[Despatch Abstract.]
Public offices at Tripattur

Estimate of Rs. 1,870 for erecting a plain wire fence round the compound of the
— in the Salem district, sanctioned with remarks.

GOVERNMENT OF MADRAS.

Buildings and Roads.
Civil Works.

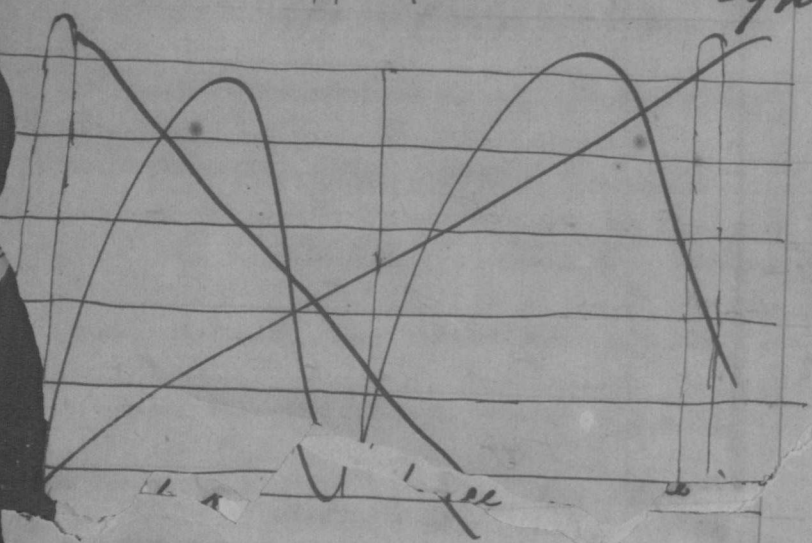
junction with the remark that it should
 provide for vertical wire ties half way
 between each support, ~~as shown thus~~

By this addition, the end of the
 estimate will be raised
 to \$18,300.

3. It did be noticed that
 the ~~estimating~~ ^{estimating} high
 cost of the wire fencing
 is due to the large number
 of straining pillars attached
 this is ~~necessary~~ ^{advisable}, owing
 to the large number of
 angles. The fence enclosing
 several different buildings
